STATE OF MAINE
DEPARTMENT OF TRANSPORTATION
16 STATE HOUSE STATION
AUGUSTA, MAINE 04333-0016

April 22, 2026
Subject: Pedestrian Safety and
Access improvements to sidewalk-
crosswalk network on Route 2
WIN:026300.00 & 026500.00
Location: Norridgewock
Amendment No. 1

~ RECTANGULAR RAPID FLASHING BEACON ASSEMBLY DETAIL ~
 ITEM NO. 643.621
 (SOLAR POWERED, RADIO ACTIVATED)

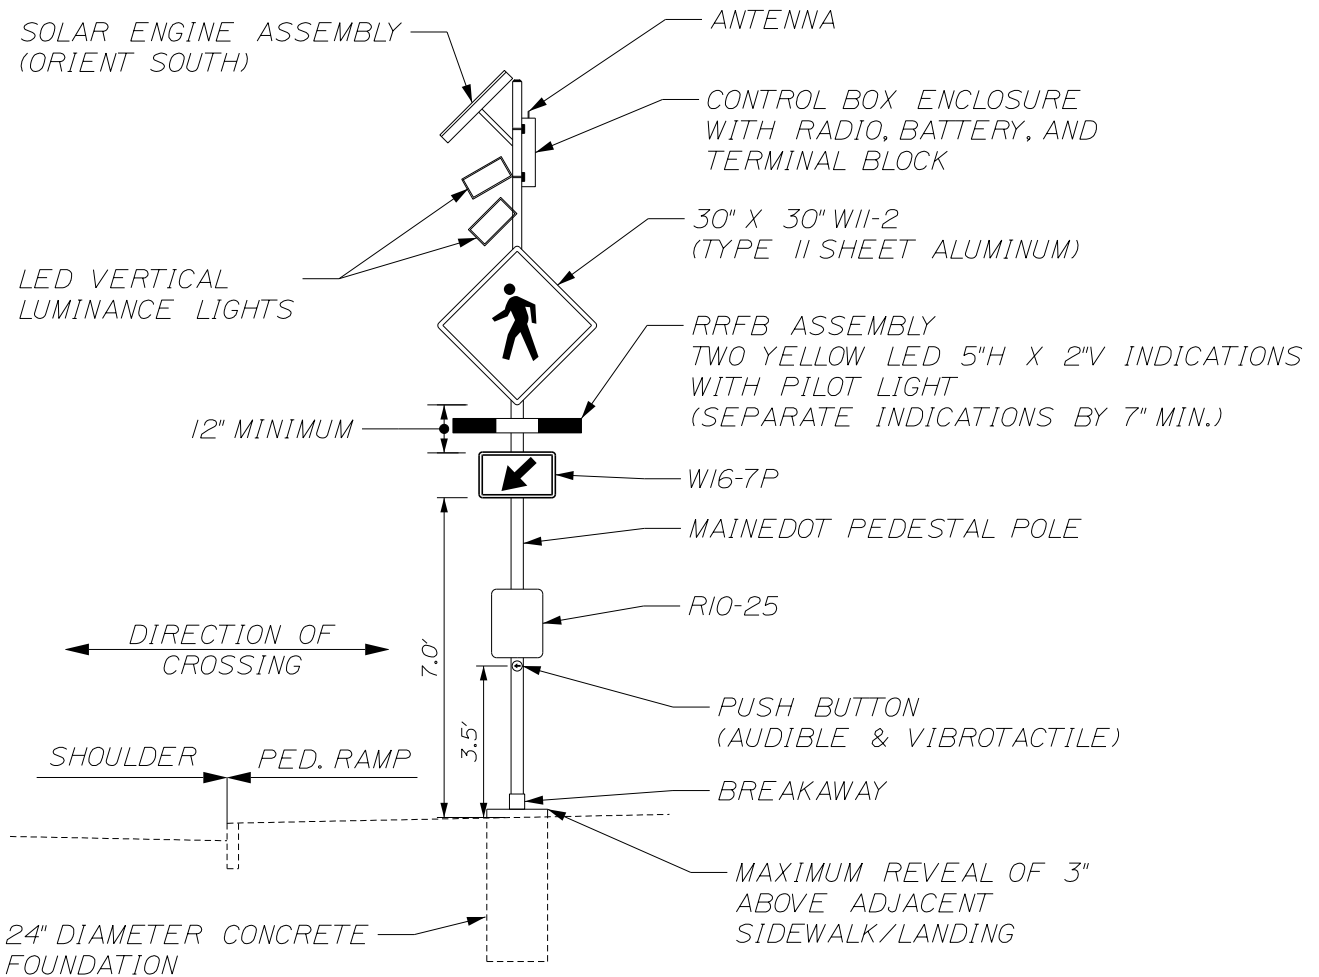
Insert the attached RECTANGULAR RAPID FLASHING BEACON ASSEMBLY DETAIL

1. FLASH DURATION FOR CROSSING SHALL MEET MUTCD REQUIREMENTS.
2. INSTALL RIO-25 SIGNAGE AND PUSH BUTTON TO ALIGN TO DIRECTION OF CROSSING.
3. PEDESTRIAN PUSH BUTTONS SHALL BE ADA COMPLIANT AND BE INSTALLED AT 3.5 FEET ABOVE ADJACENT ACCESSIBLE SURFACE GRADE.

4. MAXIMUM ALLOWABLE REACH DISTANCE FOR PEDESTRIAN PUSH BUTTONS IS 10 INCHES. INSTALL EXTENSION BRACKETS IF REQUIRED. PAYMENT FOR EXTENSION BRACKETS WILL BE INCIDENTAL TO RRFB PAY ITEM.

5. ACCESSIBLE PEDESTRIAN PUSH BUTTONS ON RRFB PEDESTAL POLES SHALL BE PROVIDED WITH A SPEECH MESSAGE. SPEECH MESSAGES SHALL BE "(STREET NAME), YELLOW LIGHTS ARE FLASHING FOR (STREET NAME)". SPEECH MESSAGES SHALL BE REPEATED AT LEAST TWICE FOR EACH PUSH BUTTON ACTIVATION.

6. ALIGN W11-2 RRFB ASSEMBLY AND W16-7p TO FACE TRAFFIC.
7. RRFB GROUPINGS AT EACH CROSSWALK SHALL BE INTERCONNECTED WITH SPREAD SPECTRUM WIRELESS RADIO COMMUNICATIONS.

8. ALL FIELD WIRING SHALL BE NEATLY BUNDLED AND CLEARLY IDENTIFIED WITH PERMANENT, LEGIBLE, WEATHERPROOF TAGS SECURELY ATTACHED TO EACH CABLE.
